SUNDRY NOTICES AND REPORTS ON WELLS

Navajo Tribal H

Attachment to Notice of
Intention to Abandon

Re: Permanent Abandonment

Plugging instructions requested. Diagram attached.

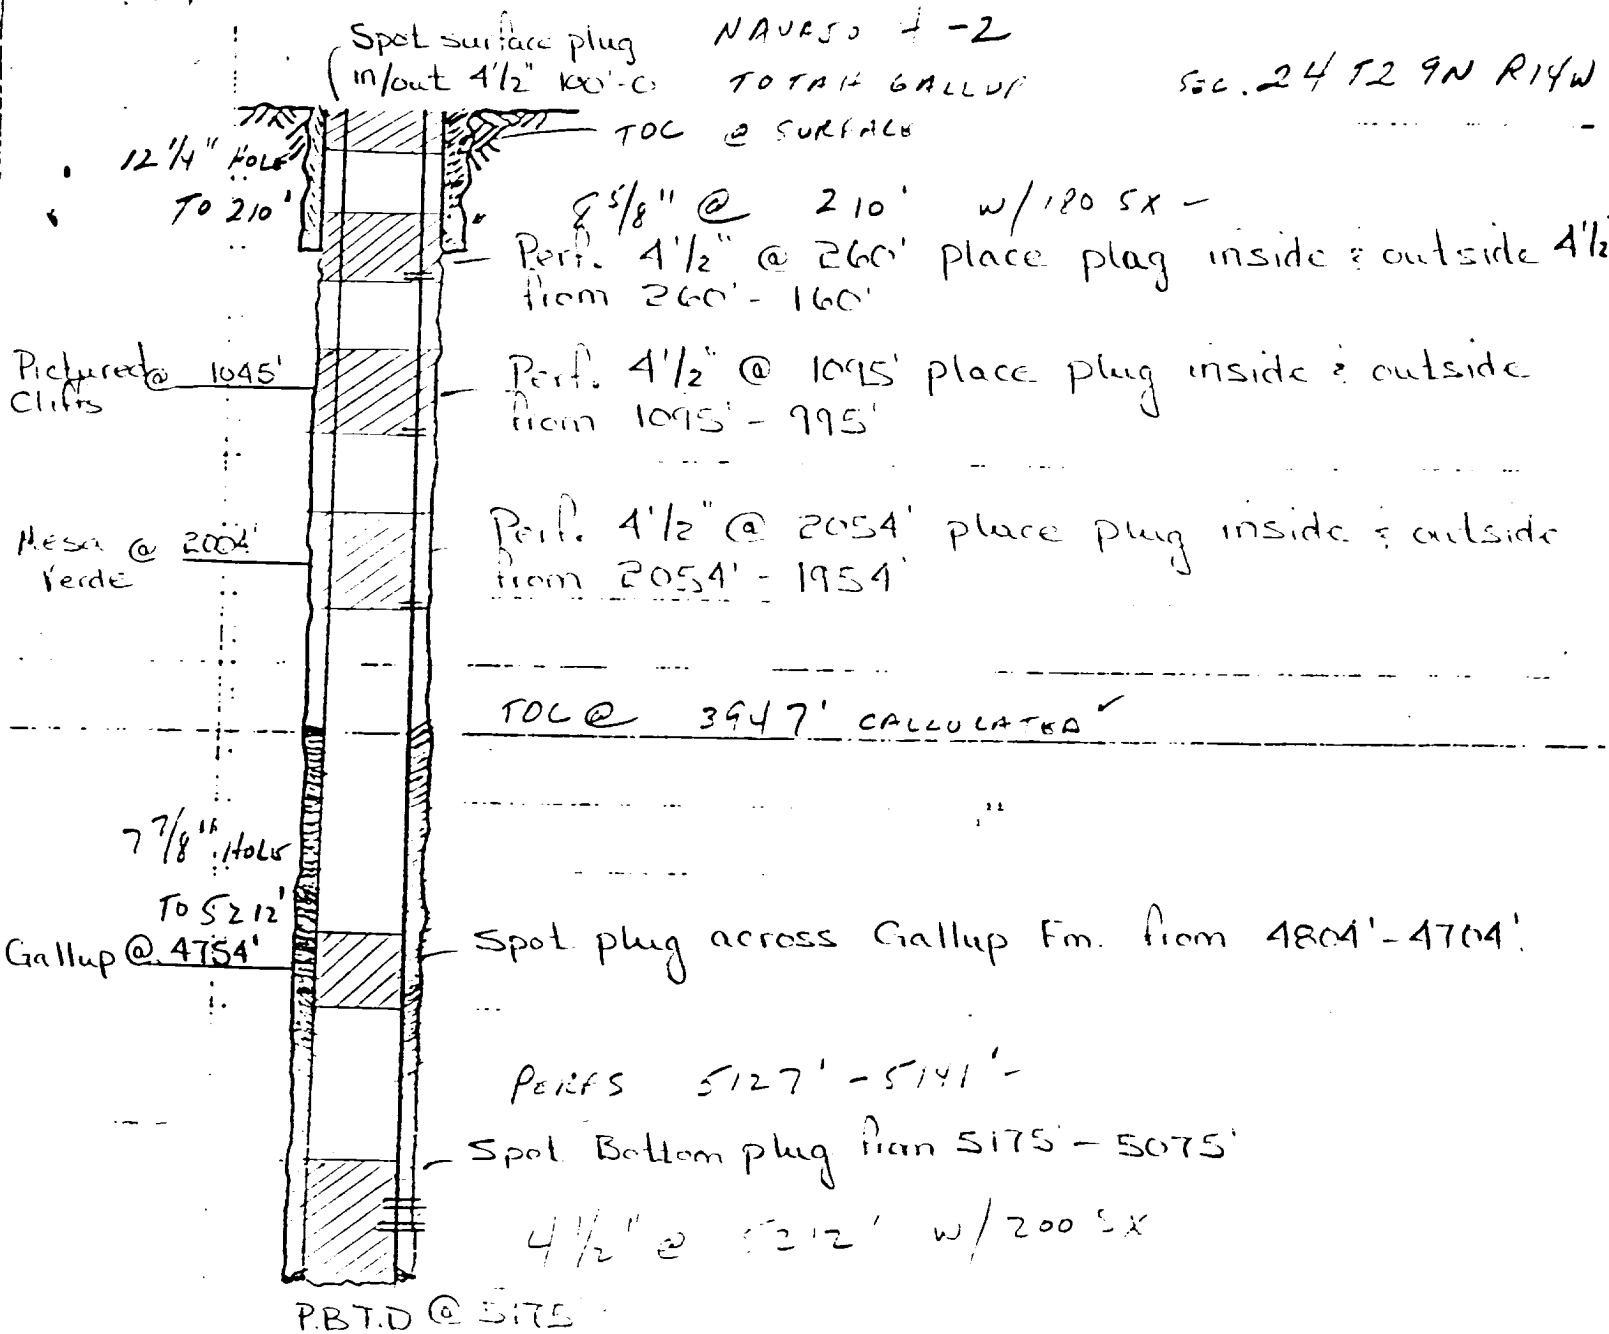
APPROVED
AS AMENDED
DATE

5. The following modifications to your plugging program are to be made (when applicable):

- 1) Spot bottom plug across perfs. from 5175' - 5075'
- 2) Spot plug across Gallup fm. from 4804' - 4704'
- 3) Perforate 4 1/2" @ 2054, place plug inside & outside from 2054' - 1954'
- 4) Perforate 4 1/2" @ 1095, place plug inside & outside from 1095' - 995'
- 5) Perforate 4 1/2" @ 260, place plug inside & outside from 260' - 160'
- 6) Spot surface plug inside & outside 4 1/2" from 100' - 0'.
